23 January 2020

Waikato District Council  
Private Bag 544  
Ngaruawahia 3742  
New Zealand

**Re: Further Information Request, s92 Response – McPherson Quarry, Mangawhiri**

VIEW LOCATION SEVEN - PROPOSED STAGE 3 VIEW LOOKING EAST FROM MT WILLIAM (WITH MITIGATION PLANTING)

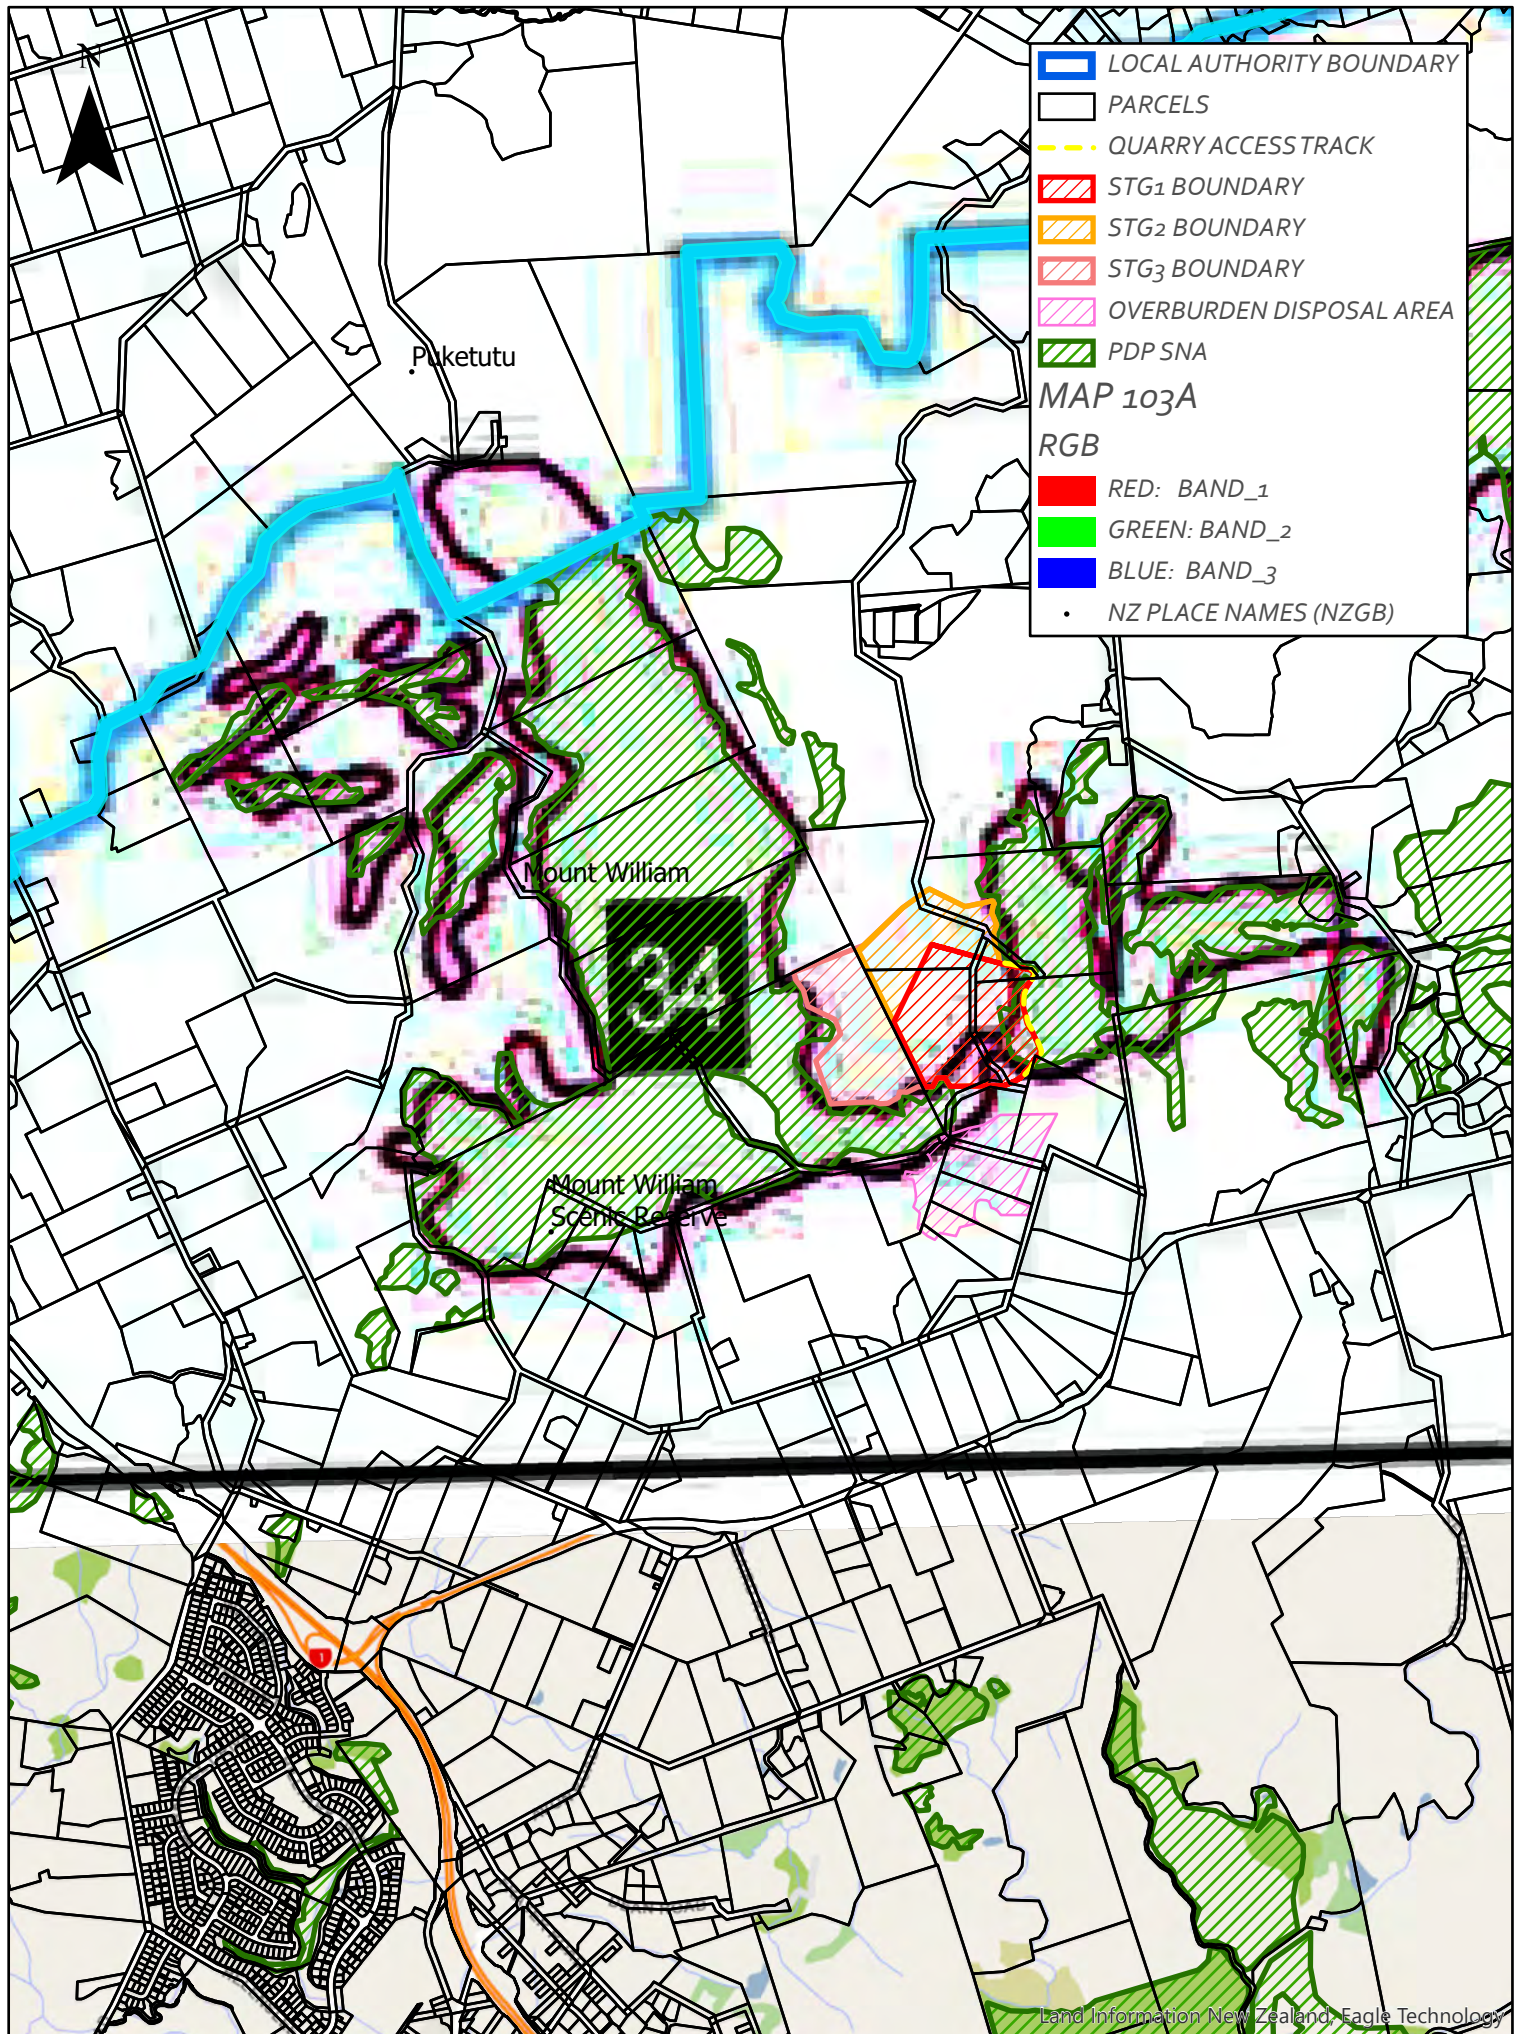
- *Has the Overburden Disposal Area (ODA) been modelled in the Visual Simulation? The ODA is described as partially visible in the assessment but cannot be seen in the Visual Simulation.*

- *Is it concluded that the overall visual effects will be less than minor, as concluded in the Opus assessment? The increased level of effects experienced in the VP4, VP6 and VP7 to moderate and high would suggest that this may have changed. Could MGLA confirm how the additional viewpoints are considered in the round for the overall conclusions?*

however, be backdropped by the major skyline ridge beyond the site.	
VL7	Mt. William Summit (Public)	Stg1= <i>Neutral</i> Stg2= <i>Very Good</i> Stg3= <i>Poor</i>	<p>Due to the ability to view the site (direct views from Mt. William), lack of intervening topography and vegetation, all 3 stages will be clearly visible. The percentage of exposed land will significantly increase through all stages.</p> <p>The proposed overburden disposal area will also be partially visible from this location.</p> <p>The lower benches and pit floor will remain screened by the foreground vegetation.</p> <p>Due to the scale, shape and appearance (including colouring of exposed land) of the proposed quarry, the landscape (surrounding rural land and vegetation) will be less able to absorb these land use changes from this VP compared to surrounding VP's.</p>	Stg1= <i>Low-Moderate</i> Stg2= <i>Moderate</i> Stg3= <i>High</i>

The overburden disposal area (ODA) is not shown in the visual simulation supplied to Council. The layer showing this aspect was accidentally left switched off on the proposed montages. This has been corrected in the attached montages.

It should be noted that the visual simulations represent the end of each stage of extraction (i.e. completed pit and overburden disposal). Because overburden stripping and disposal will occur at the beginning of each stage, the ODA will be at a point where it already has been filled and regressed. During overburden stripping and placement, a small portion of the overburden stockpile area will be exposed to view while
